POST OAK TRILT SUBDIVISION
ZONING PLAN
LAND LOT 601, 16TH DISTRICT, 2ND SECTION
COBB COUNTY, GEORGIA

PETITION NO.: Z-43

PETITION FOR: R-15 and RA-5

ZONING COMMENTS:

**Z-43
(1011)**

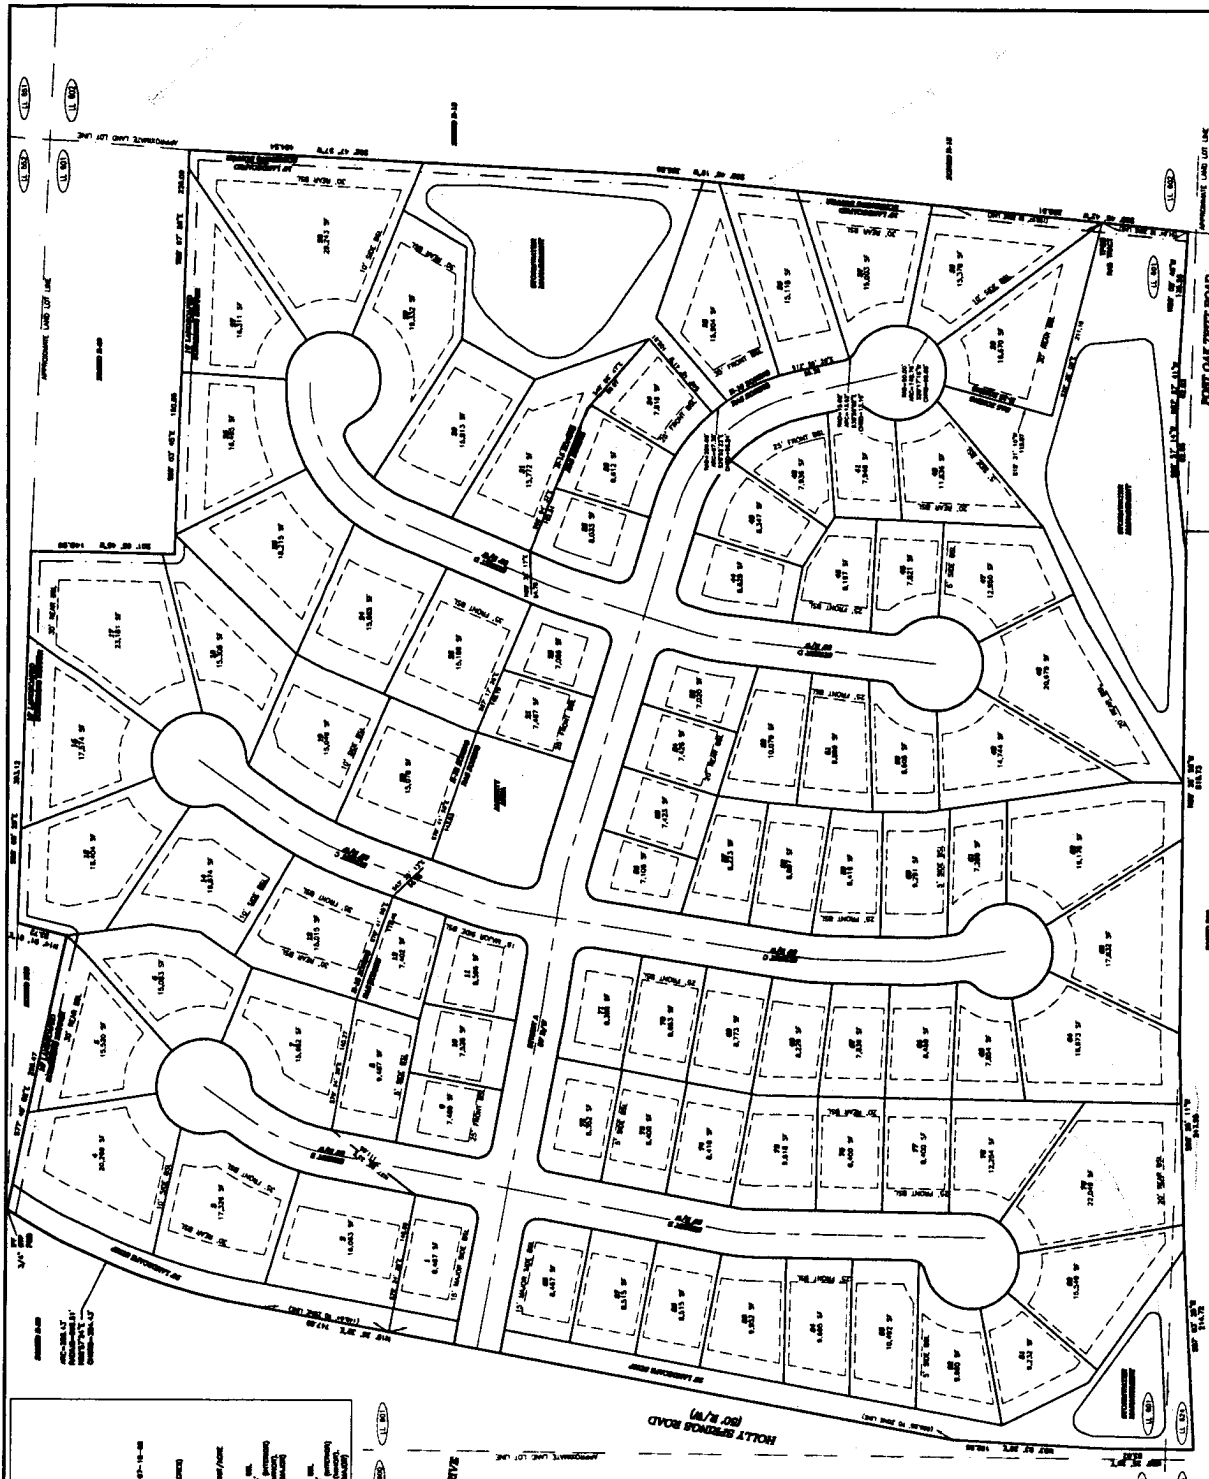
Applicant is requesting the R-15 and RA-5 zoning categories in order to develop a single-family detached subdivision. The proposed site plan indicates that most of the of the development (19.90 acres) will be RA-5, with minimum lot sizes of 7,000 square feet and the remaining portion of the property (13.64 acres) will be R-15, with minimum lot sizes of 15,000 square feet. As indicated of the attached letter of agreeable stipulations, the minimum house size will be 2,200 square feet and shall range up to 4,200 square feet and beyond. The architectural style and composition of the homes shall consist of a combination of either brick, stacked stone, cedar and/or hardi-plank shake and hardi-plank siding on all four sides consistent with the attached renderings. The homes will also have, at a minimum, an attached two-car garage. The homes will range in price from the high \$300,000s to \$500,000s. The proposed site plan also indicates an amenity area that will include a swimming pool and associated clubhouse. A 10-foot landscape screening buffer is also indicated along the northern and eastern property lines and a 25-foot landscape strip along the Holly Springs Road frontage.

Applicant is seeking simultaneous variances for the interior rear setbacks of the RA-5 portion from the required 30 feet to 20 feet and a waiver of the minimum major side setback in the RA-5 portion from the required 20 feet, 25 feet or 35 feet to 15 feet

2. This development is proposed with mixed density. If approved, the stormwater management facilities must be designed to accommodate the maximum allowable impervious coverage (35% for R-15 and 40% for RA-5). The proposed detention pond at the southwest corner of the site must be designed to tie directly into the existing catch basin located in the Holly Springs Road right-of-way.

Recommend no access to Post Oak Tritt Road.

Recommend a deceleration lane on Holly Springs Road at proposed development.
